PHOENIX HOMES

YARMOUTH-2007-B

SITE: FERNBANK

CIVIC ADDRESS:
68 GINSENG TERRACE

BASEMENT PLAN "B"

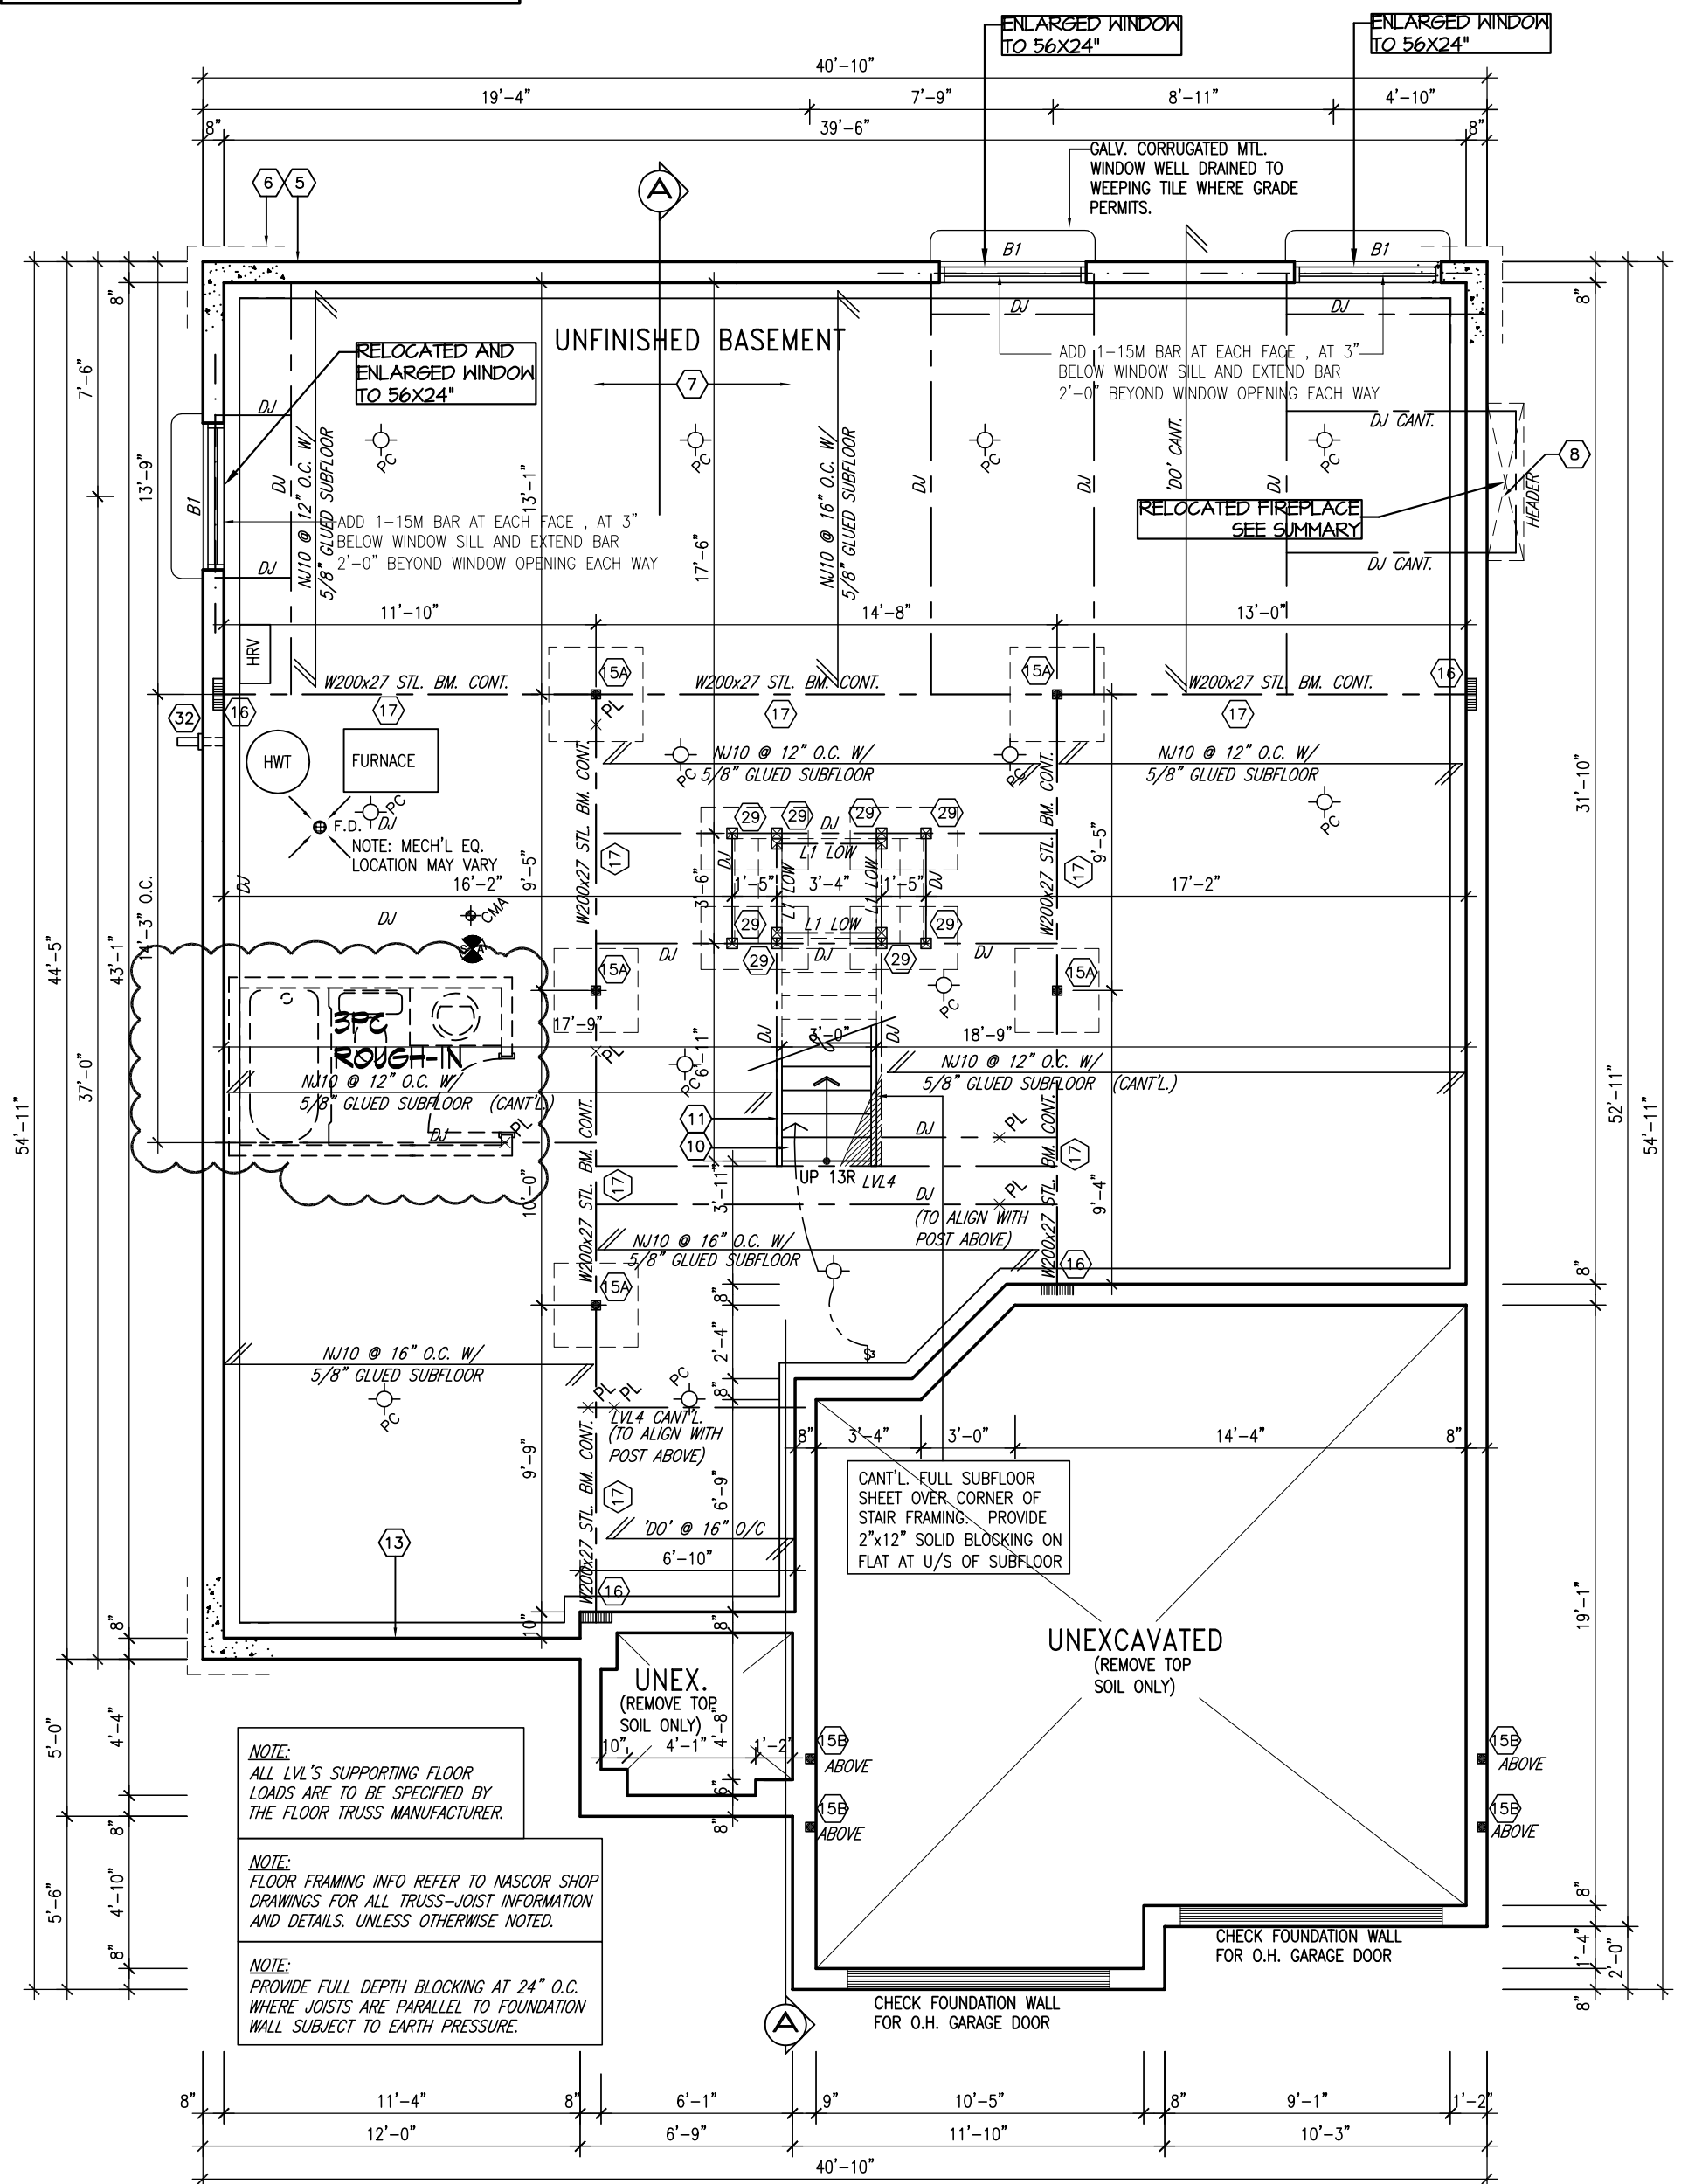
NOTE:
FLOOR JOIST LAY OUT WAS
REVISED TO MATCH NASCOR'S
LAYOUT FOR UNIT 511,
NASCOR JOB N#. Q06-00762
/ 63 DATED 02-03-06.

GROUND FLOOR PLAN "B"

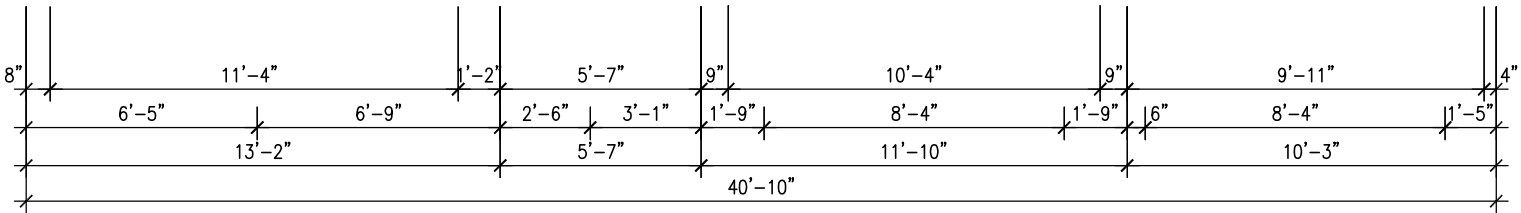
(2) PAR20
POTLIGHTS
SEE SUMMARY
RELOCATED
STOVE

M/W SHELF SEE
KIT. PLAN

NEW OPENING 36"
WIDE SEE SUMMARY

RELOCATED
SWITCH

(2) CAPPED LIGHT
OUTLETS FOR FUTURE
SCONCES AT 4'6"
AFF. SEE SUMMARY

ENLARGED DOORS TO 36"W
AND REDUCED SIDELITES
TO 10" WIDE, SEE SUMMARY

RIGHT SIDE ELEVATION 'B'

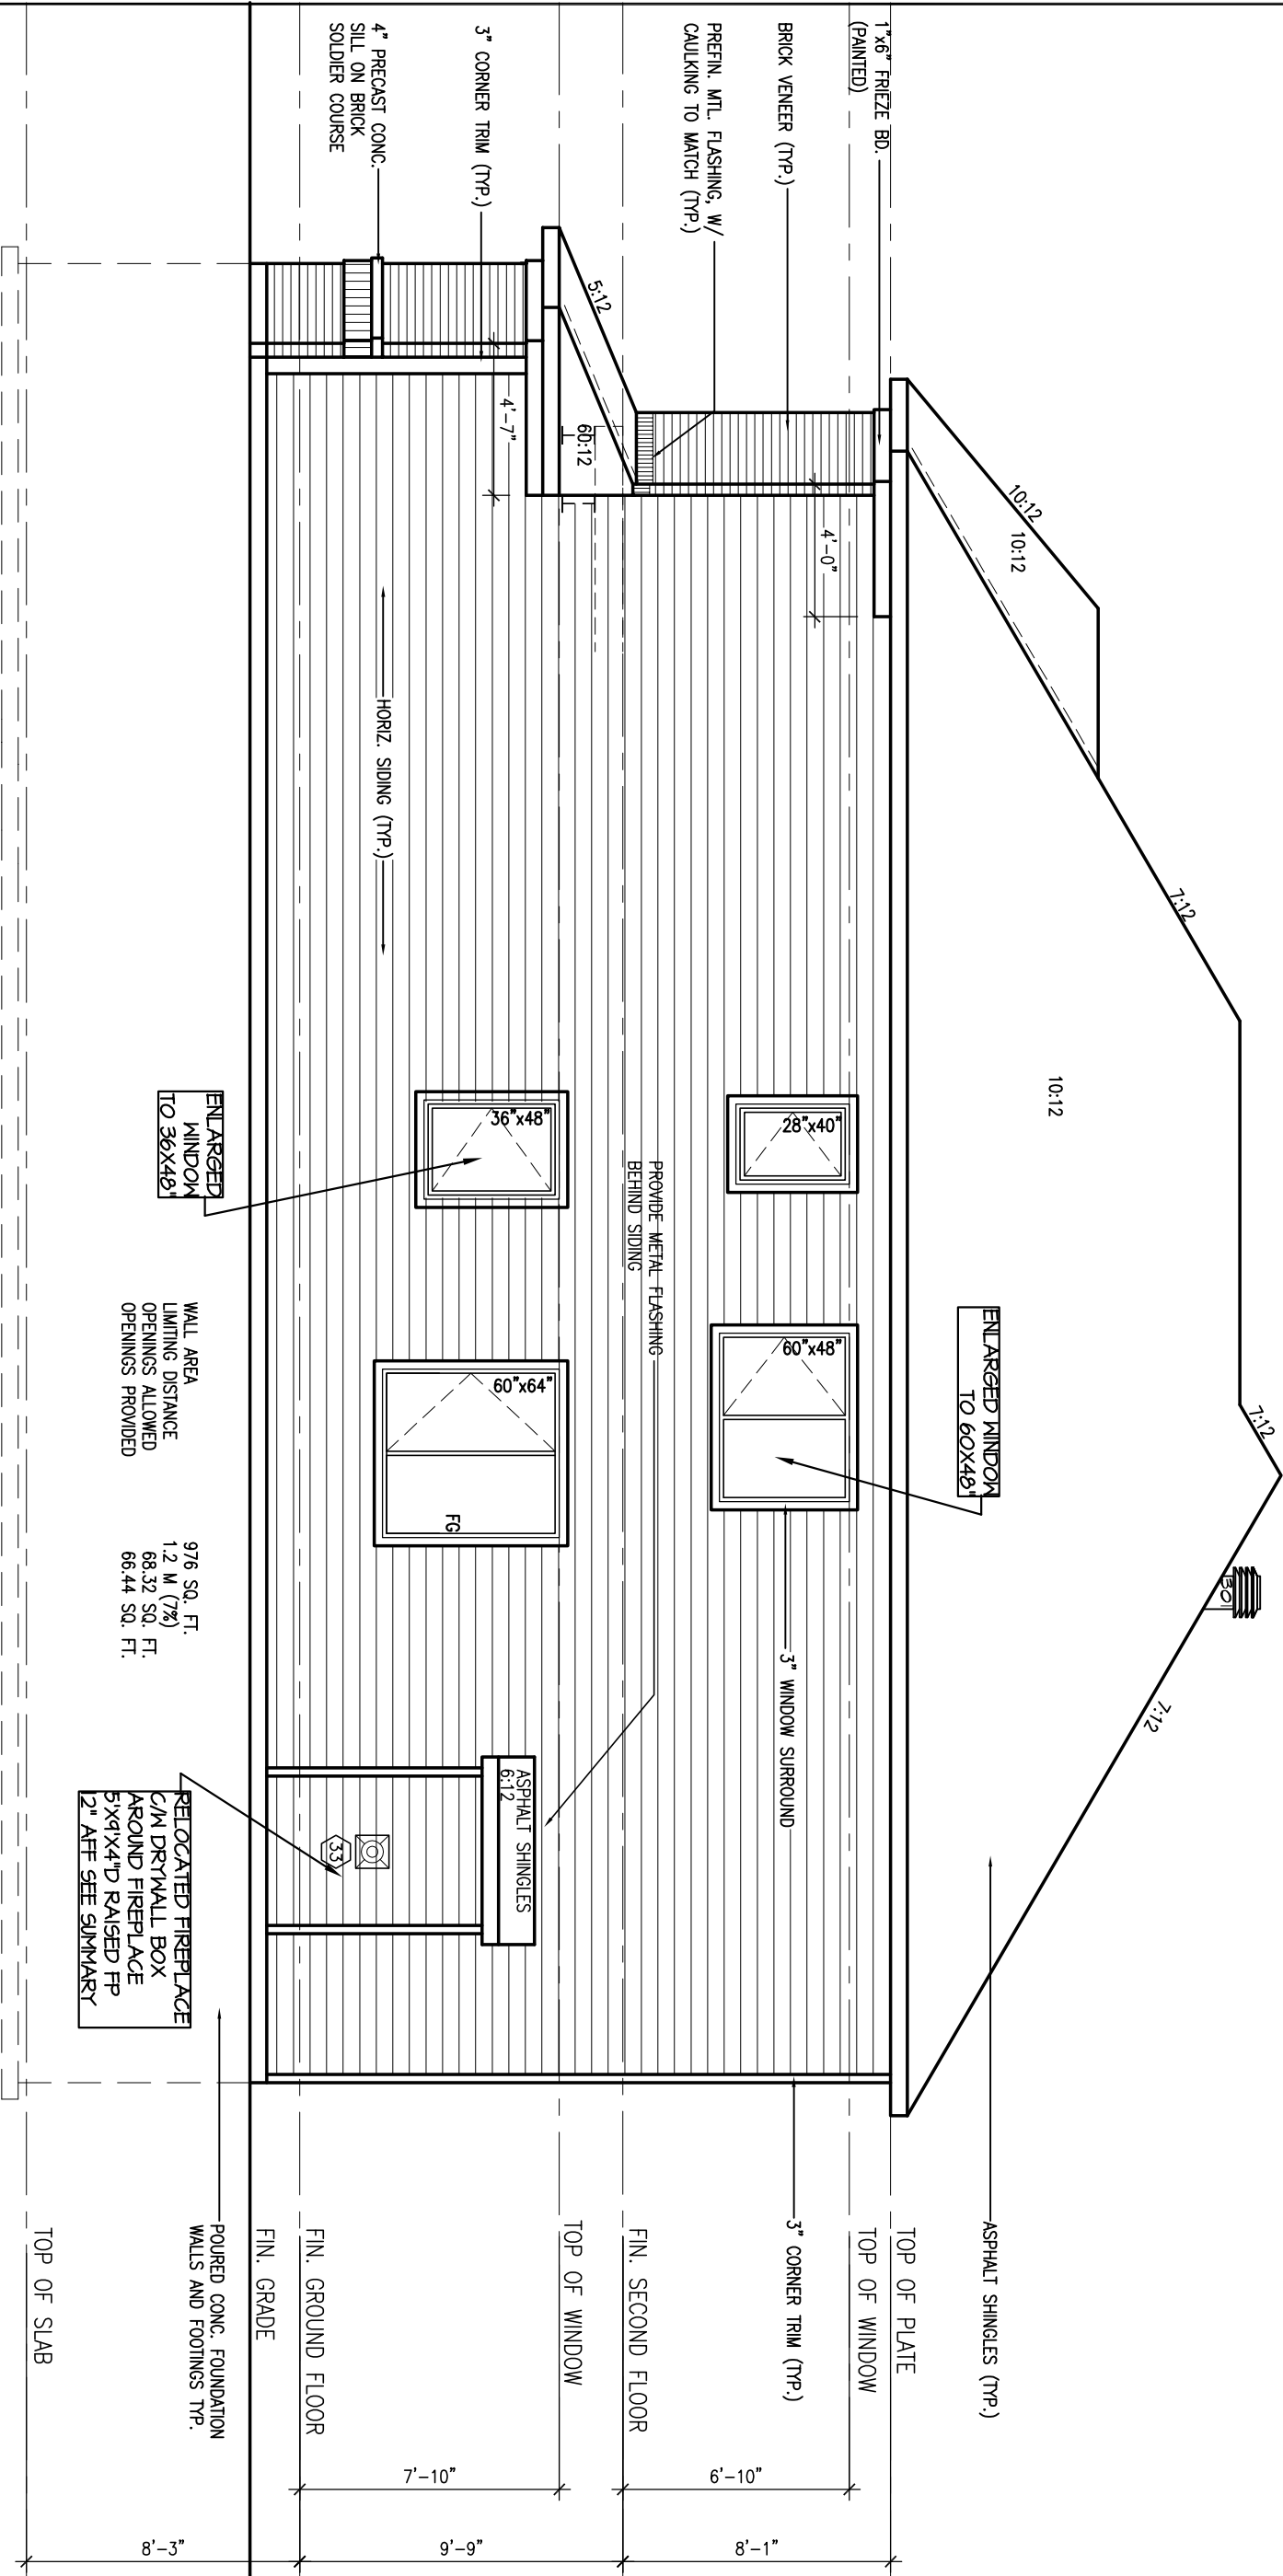
RELOCATED FIREPLACE
C/M DRYWALL BOX
AROUND FIREPLACE
5"x9"x4" RAISED FP
12" AFF SEE SUMMARY

3 WINDOWS, 48"x64" IN LIEU
OF STD, SEE SUMMARY DUE
TO FIREPLACE RELOCATION

REAR ELEVATION
(4 BEDRM.+MEDIA RM.)

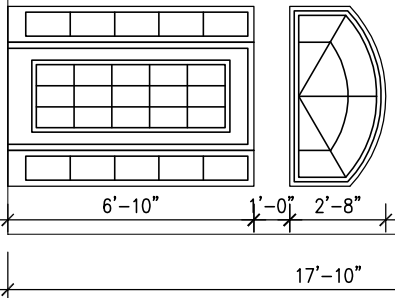
ENLARGED WINDOWS
TO 56"x24"

RELOCATED PATIO DOOR
DUE TO KITCHEN RE-DESIGN

RELOCATED AND REDUCED
WINDOW DUE TO KITCHEN
RE-DESIGN SEE SUMMARY
